## IN THE UNITED STATES PATENT AND TRADEMARK OFFICE

In Re:	Paul Mattackal Verghese	Confirmation No:	6972
Serial No:	10/743,238	Group:	2872
Filed:	December 22, 2003	Examiner:	Chang, Audrey Y.
For:	Dual Membrane Single Cavity Fabry Perot MEMS Filter		
Customer No.:	25263		
Attorney Docket No.	0005.1120US1

### **Petition Under Rule 181**

FIG. 1

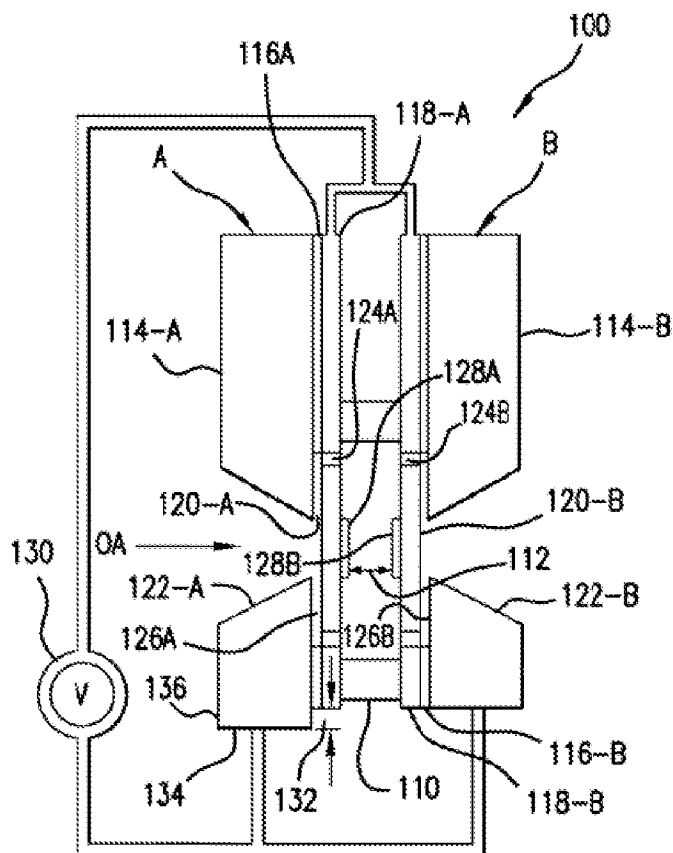
1. The drawings were objected to under 37 C.F.R. § 1.83(a) for failing to show every feature of the claimed invention. Specifically, the Office Action stated that the “optical port through the substrate of at least one of the first membrane device” of claims 8 and 17 was not shown in the drawings.

1. The drawings were objected to under 37 C.F.R. § 1.84(p)(4) because of the use of reference characters. Specifically the Office Action states: "reference characters "114-A and (114-B)" and "122-A (and 122-B)" have **both** been used to designate the substrate."

The drawings do not use the same reference characters for different elements contrary to the assertion from the Office Action that: "reference characters "114-A and (114-B)" and "122-A (and 122-B)" have **both** been used to designate the substrate."

Please note that reference numerals 114-A refers to the substrate of Device A and 114-B refers to the substrate of Device B. Similarly, 122-A refers to the port through the substrate 114-A, and 122-B refers to the port through substrates 114-B of Device B.

The drawings show "an optical port through the substrate of at least one of the first membrane devices" contrary to the Office Action. The optical port through the substrate is clearly shown in the figure. Specifically, Fig. 1 shows a first optical port 122-A through substrate 114-A of Device A.

Reference numerals 114-A, 114-B refer to different substrates for different devices.

Reference numerals 122-A, 122-B refer to different ports through different substrates of different devices.
